## Technical Update

### T46 T4 6W linkable Fluorescent

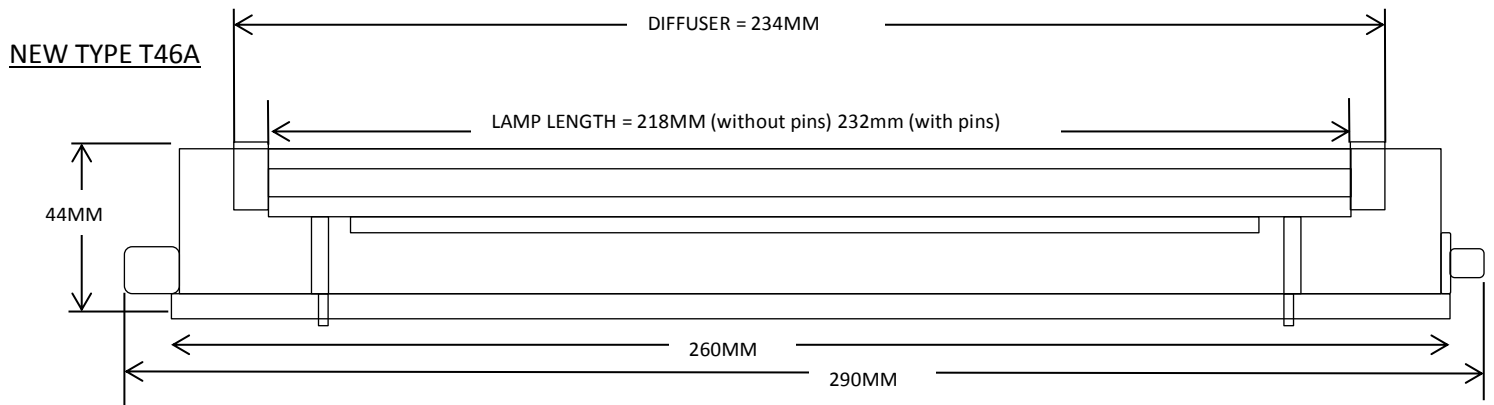
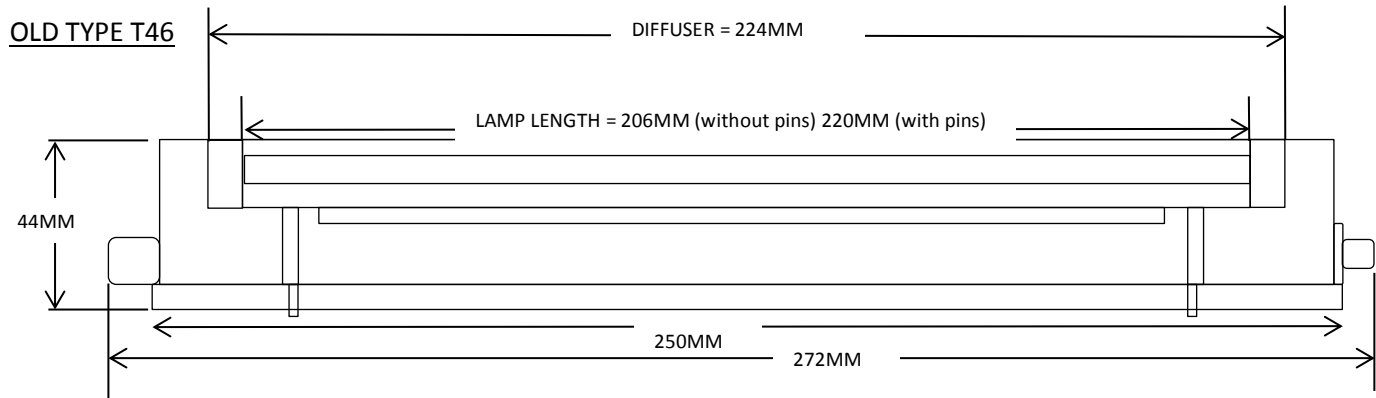
The interpretation of EN60320-2-2(Male/Female Connectors) by our test house GS has now advised that to comply with the safety standards in this document the depth of the electrical contacts on the female socket of the fitting must be increased from 3.5mm to 5.7mm this has resulted in an increase to the length of the T46.
